CITY OF TAYLOR, TEXAS

PLANNING AND ZONING COMMISSION MEETING

January 11, 2022, 6:00 P.M.

Staff has completed its review of plans for the Castlewood Phases 2 & 3 Final Plat that is to be located at 530 FM 973, Taylor 76574. There are some corrections that need to be made prior to recordation of the plat. Consequently, your plat application will be placed on the upcoming Planning and Zoning Commission Agenda, January 11, 2022. Comments from this review follow.

TOWN-HOME LOT BUILDING DETAIL "D"
SETBACKS (B.L.) & PUBLIC UTILITY EASEMENTS (P.U.E.)
-BLOCK 2-

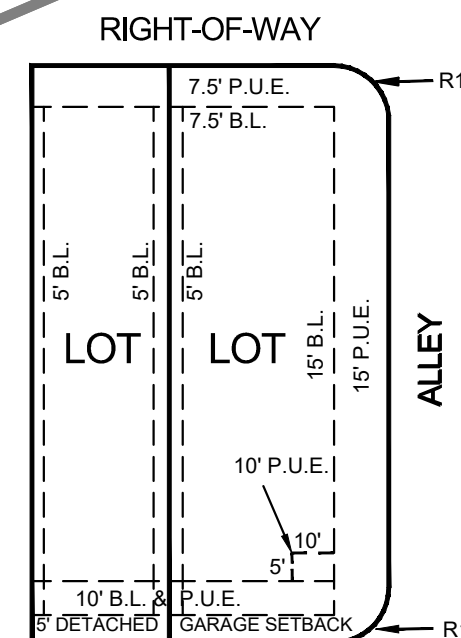
Refer to the Planned Development Ordinance in the Plan Review Uploads, Development Standards so you can get the Twin Home Detail correct. Also, it's labeled Townhome in Detail "D" which is not correct. Remove 2.5' PUE. Refer to the Development Standards Table in the Planned Development Ordinance for the setbacks when the dwelling units are not attached.

ALLEY DETAIL "B"
TOWNHOME BUILDING SETBACKS (B.L.) & PUBLIC UTILITY EASEMENTS (P.U.E.)
-TOWNHOME BLOCKS 15 & 16

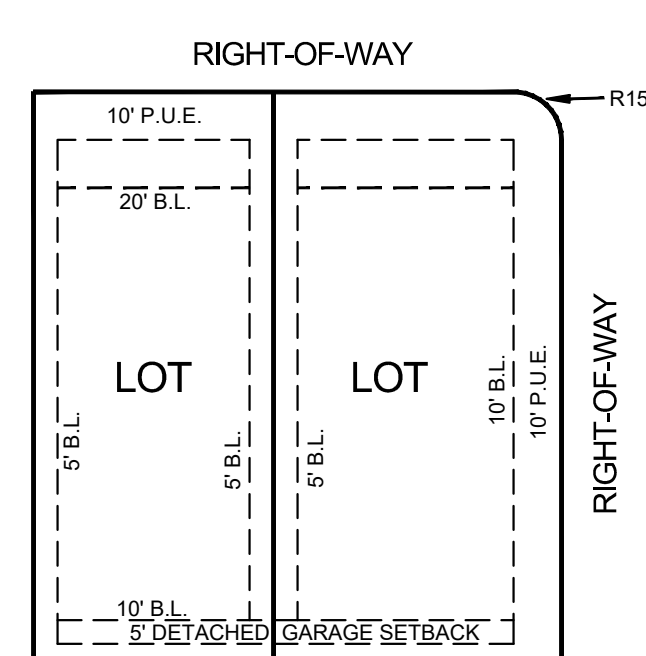
There's no rear yard setback for the Townhomes so correct the detail ("B"). The street side setback is 10-feet. The setbacks can be updated but I wanted to make sure that you have changed them intentionally.
